## Memo

| Subject | Oceana Gold: Comments on s92 response   |

This memo provides comments on the responses provided by Oceana Gold to Otago Regional Council (ORC) to the section 92 (s92) information request relating to the extension of Macraes mine (Oceana Gold Application RM16.138). Specifically this addresses responses from Greg Ryder, Ryder Consulting (letter to John Bywater dated 8 July 2016) and from Brett Sinclair, Golder Associates (letter to John Bywater dated 13 July 2016).

**Figure 39** Number of flathead galaxiids (per 10 m reach) found in summer surveys of Deepdell Creek, 1995 to 2015.

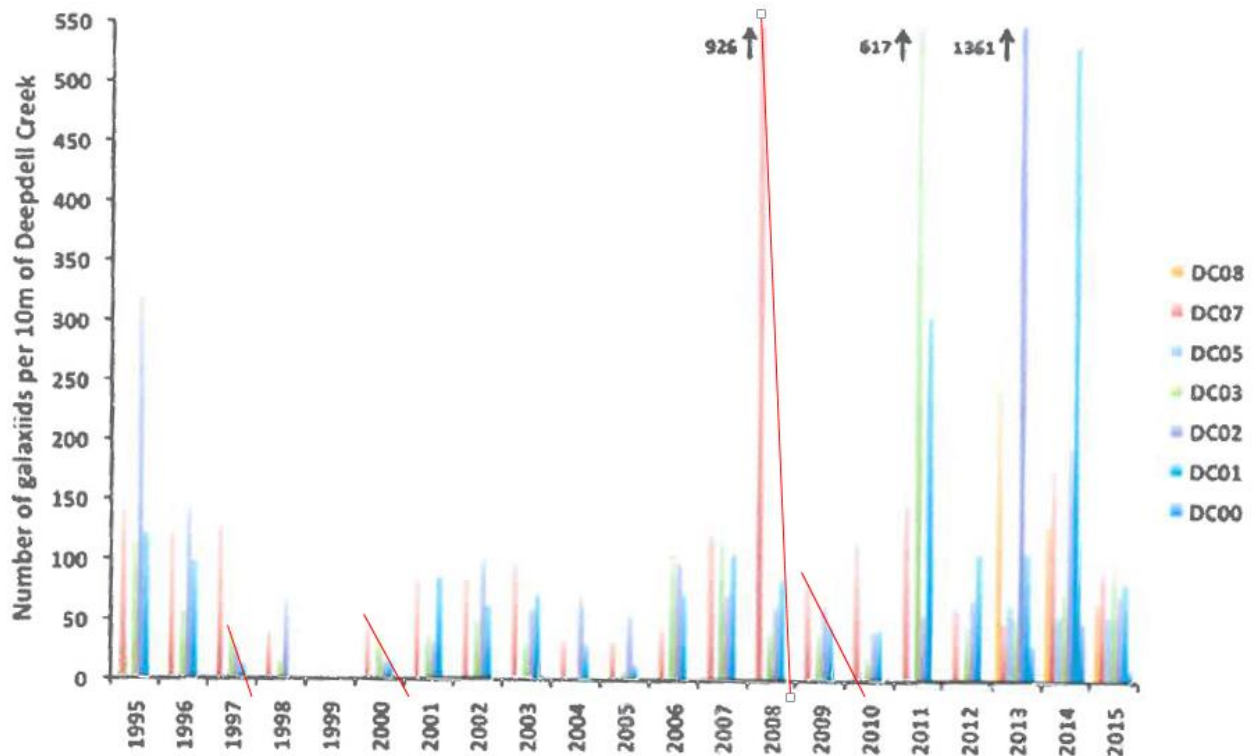
Ecological monitoring. A plot of galaxiid abundance was provided (Figure 39).

**Response:** This data could potentially provide useful information for site-specific water quality thresholds if there was concurrent water quality monitoring data available for these sites. In various years the galaxiids show marked reductions in abundance between sites – indicating that some physical or chemical factor(s) are affecting abundance (some red lines added to Figure 39 below). Such an analysis may be a useful component of the site monitoring programme and the evaluation of potential effects for this proposed expansion.
